Project Our Town Hall

Drg Title Furniture General Arrangement 1 of 3

Drg No.	Suitability	Revision
OTH-PLA-EE-ES-DWG-L-4000	S4	C02

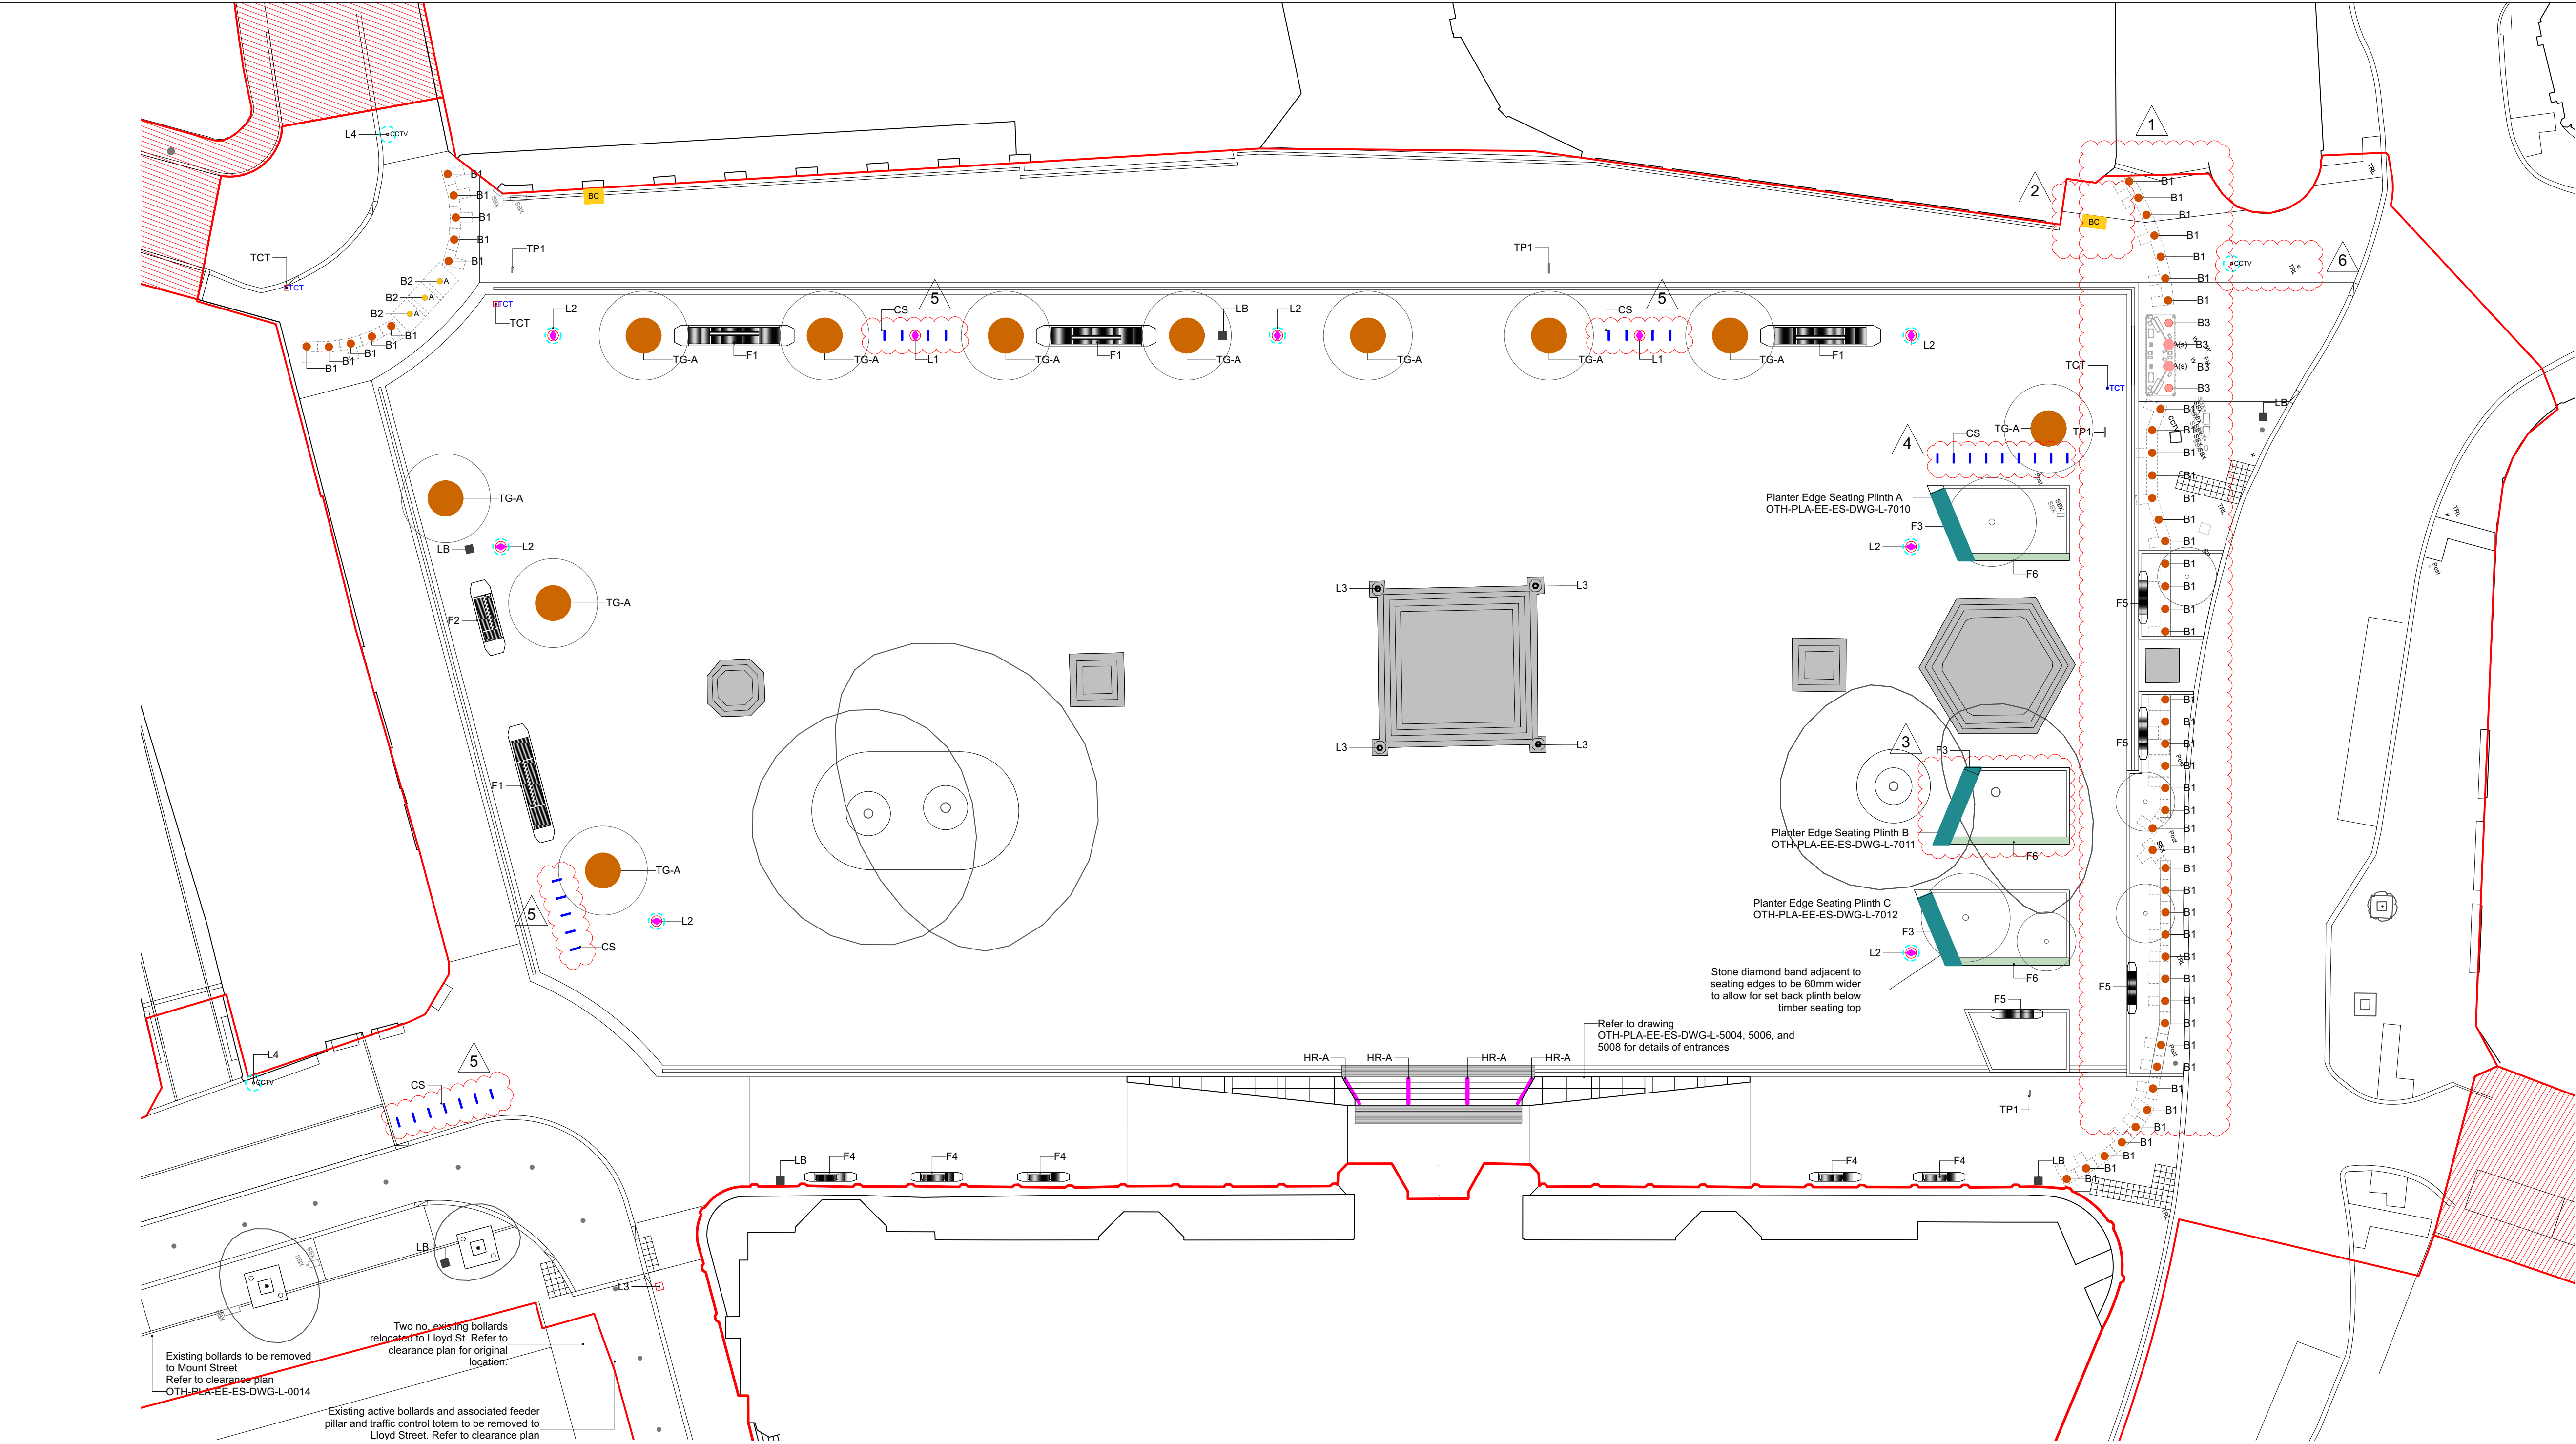
1. Updates to Princess St HVM bollard line - positions adjusted to avoid CCTV column clash and shallow services. Omission of 1no bollard due to realignment.
2. Bollard cabinet position updated as agreed with LPA.
3. Change to planter edge and seat detail to avoid existing tree root clash.
4. Relocation of cycle stands to avoid service cover clash.
5. Minor amendments to cycle stand positions / spacing.
6. Updates to TFGM equipment and lighting etc around HVM line.
